## 6 Inch Exhaust Riser Replacement

Models Covered	Serial Number Or Year
ECT 5.0L, 350, 377, 5.7L, and 6.2L engine models for Sterndrive, Inboard, and TowSport	2A437183 and below

## 6 Inch Exhaust Riser Comparison

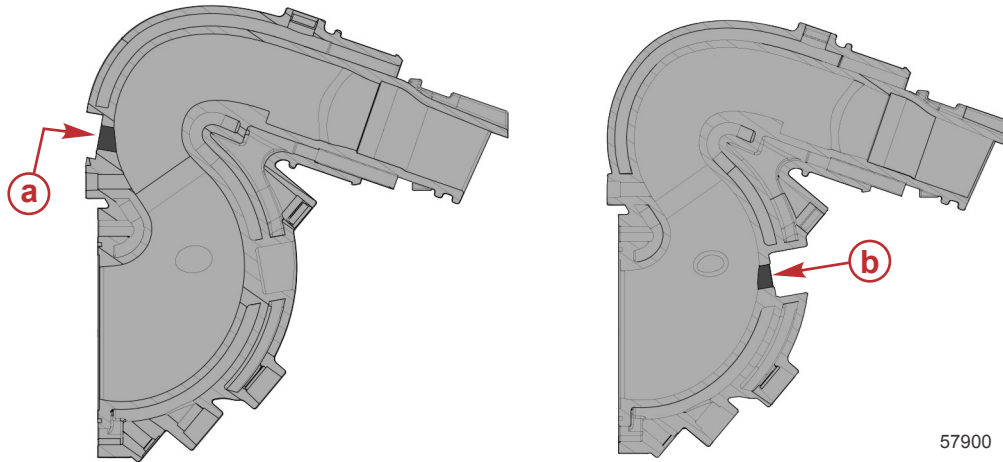
The following image shows the difference between the new style and old style exhaust risers. This will act as a quick visual for the technician when inspecting the engine for repeat post O2 sensor failures. Engines with the new style exhaust risers will not have to be checked for repeat post O2 sensor failures.

- a** - New style exhaust riser post O2 sensor location
- b** - Old style exhaust riser post O2 sensor location

The engines listed under **Models Affected** will need to have their history checked for repeat post O2 sensor failures. The engines that have been identified with repeat post O2 sensor failures will need to have the 6 inch exhaust risers replaced with the new exhaust riser kit (8M0094682).
